**North Donahue Widening Phase 1  
City of Auburn, Alabama**

**Addendum 1  
September 18, 2026**

**DONAHUE PHASE 1 WIDENING PROJECT  
MANDATORY PRE-BID MEETING SUMMARY  
SEPTEMBER 14, 2026**

| North Donahue Drive Widening Phase 1 Pre-Bid RFI's |                                                                                                                                                                                                                              |                                                                                                                                                                        |

| SHEET NO. | C4.0                   |

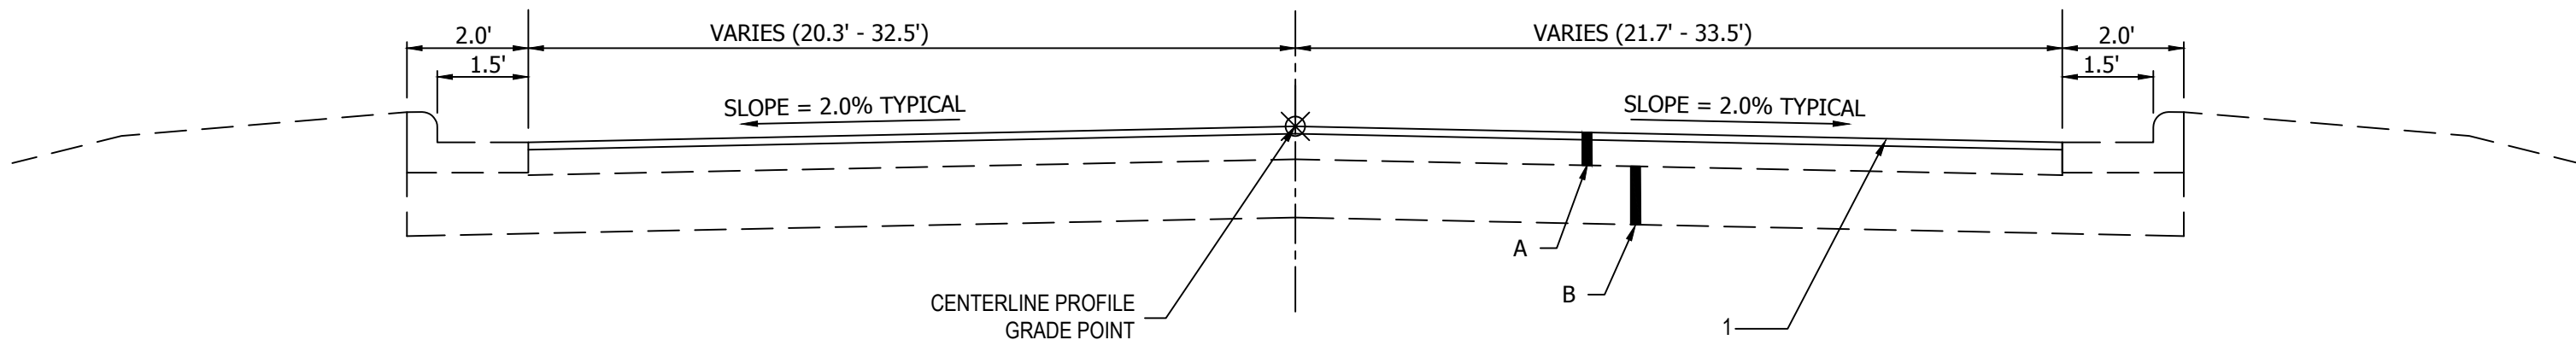
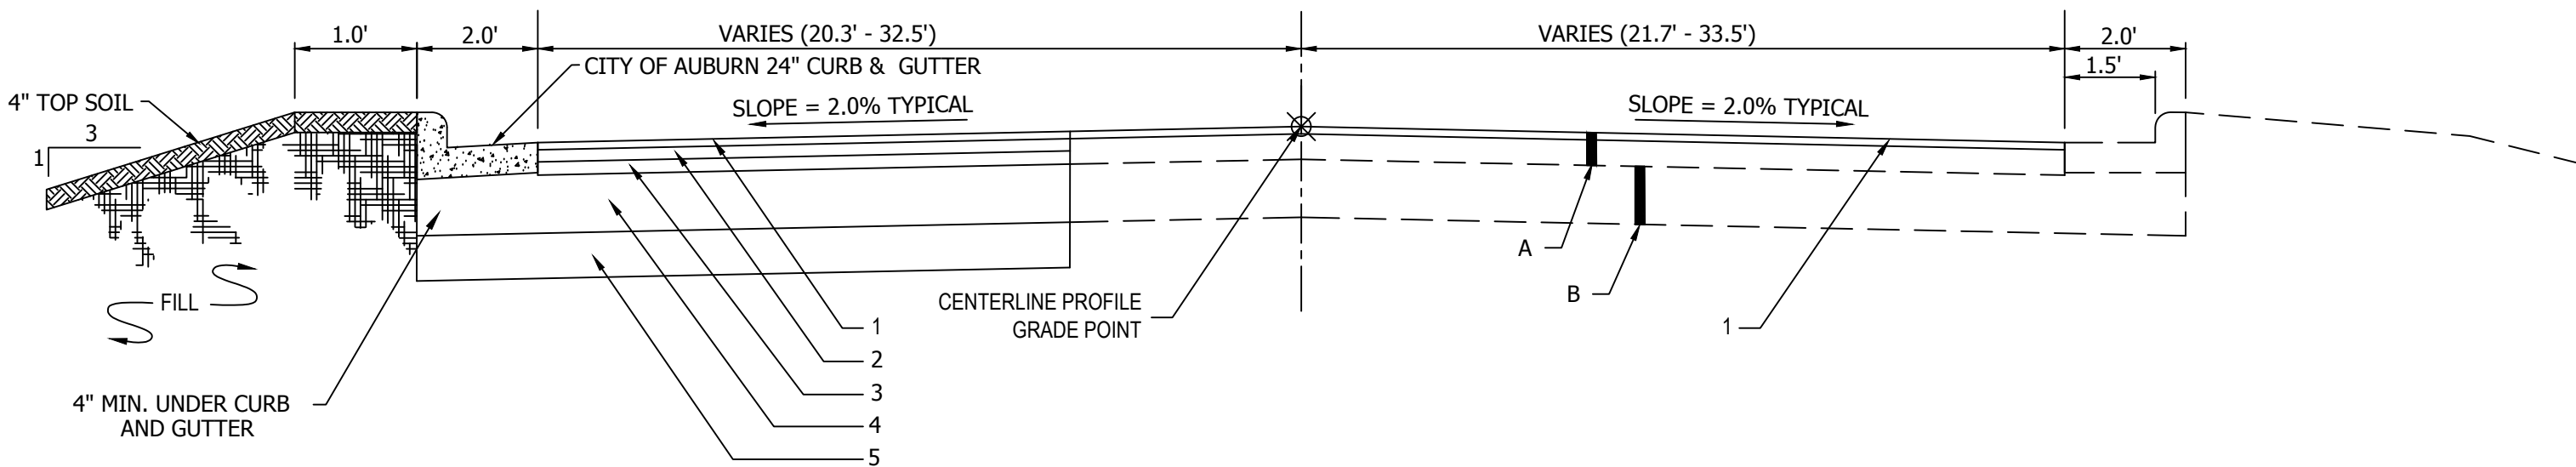
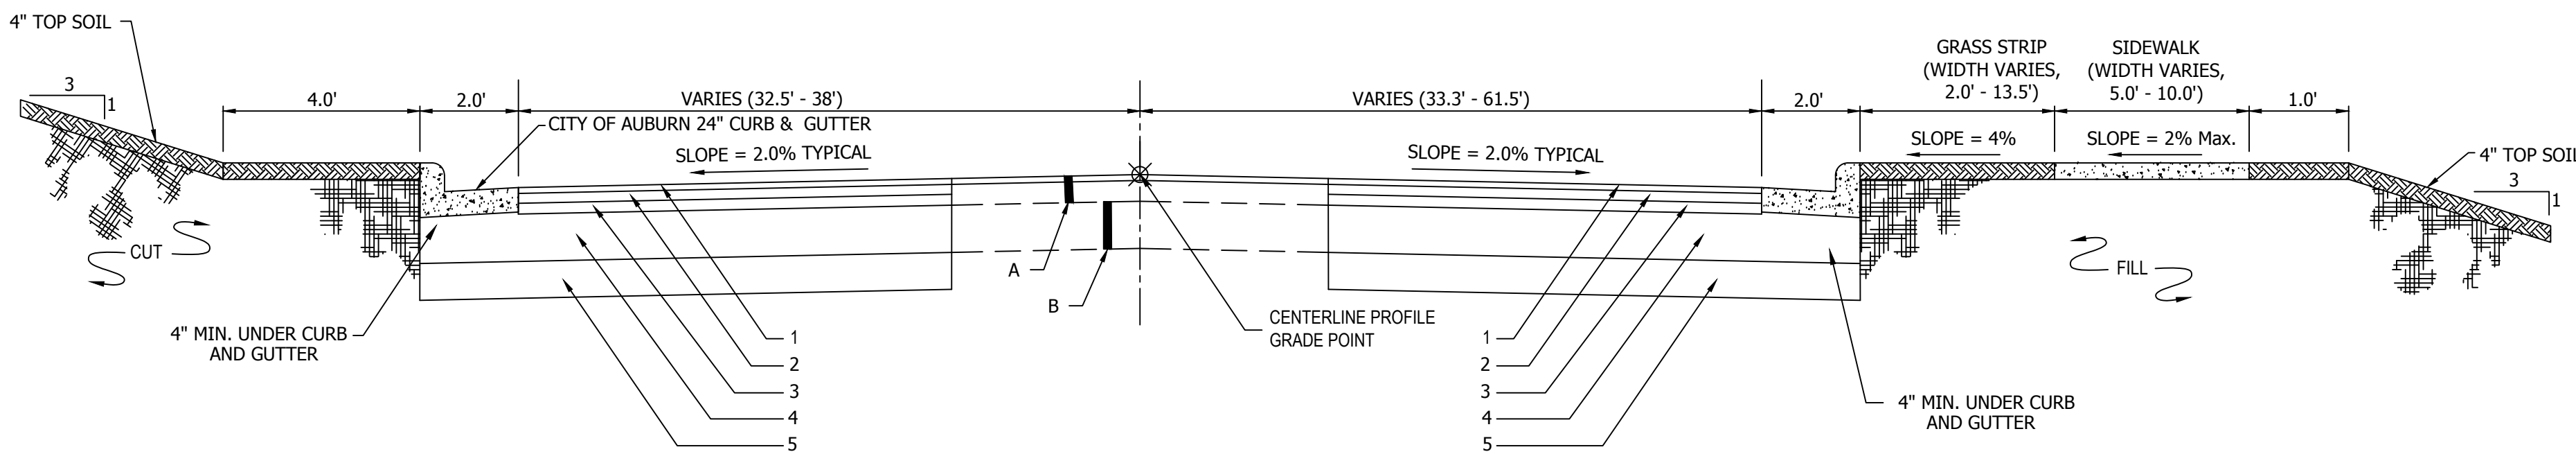
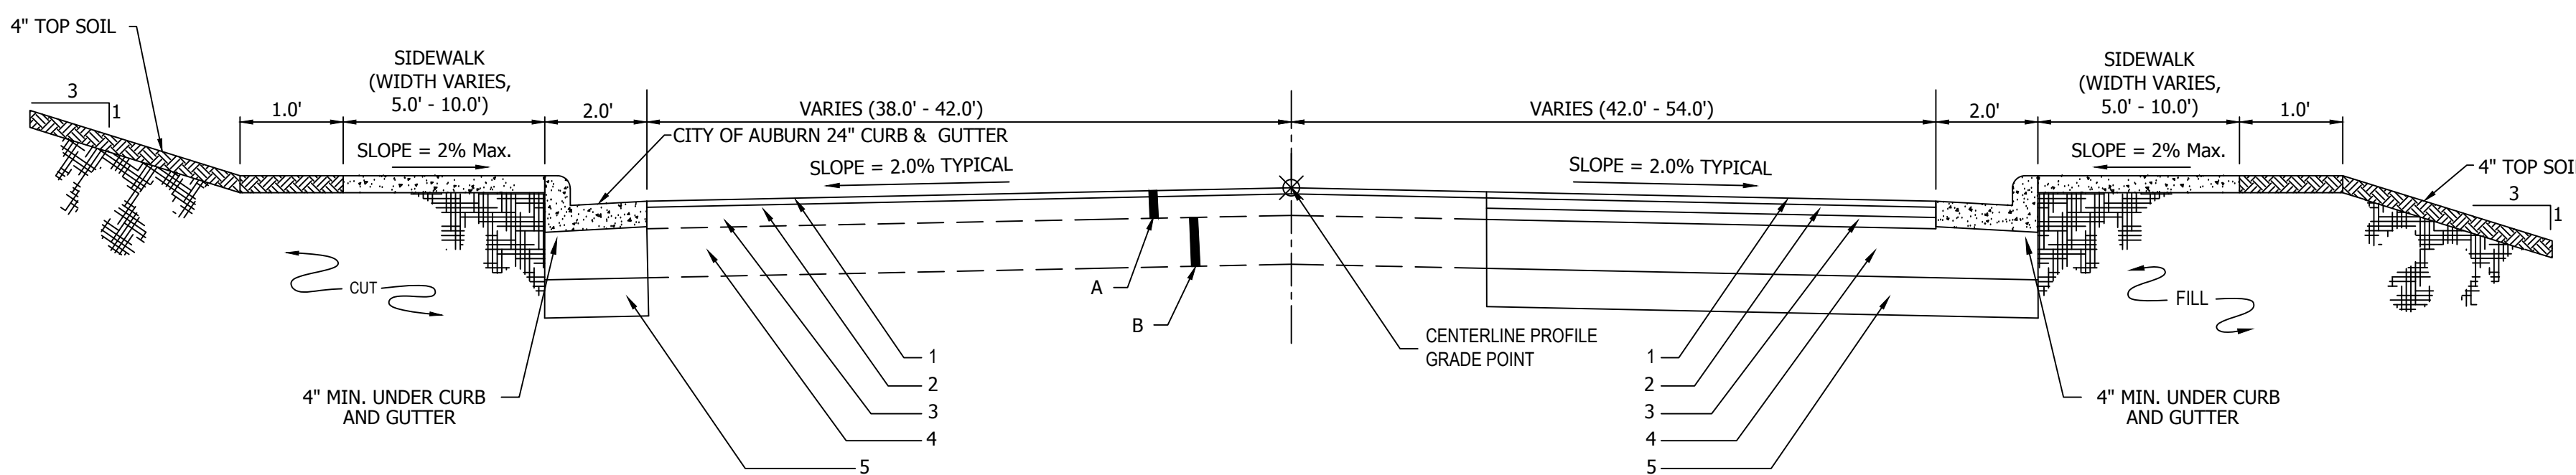
| North Donahue Drive Widening Phase 1 Pre-Bid RFI's |                                                                                                                                                                                                                              |                                                                                                                                                                        |
|----------------------------------------------------|------------------------------------------------------------------------------------------------------------------------------------------------------------------------------------------------------------------------------|------------------------------------------------------------------------------------------------------------------------------------------------------------------------|
| 9                                                  | The Typical sections note for "A" & "B" on pages C4.0 -C4.4 indicate the existing roadbase and pavement are to " plane and retain".<br>Please confirm the existing N Donahue Dr roadway is to be milled and overlaid per the | The station of transition from plane and retain to full depth has been revised on the typical section to match the plan view. The correct station is 12+85.            |

|    | typical section. The plan call outs indicate new full asphalt build up but the typical indicate mill and overlay of the existing. Please advise                                               |                                                                                                                             |
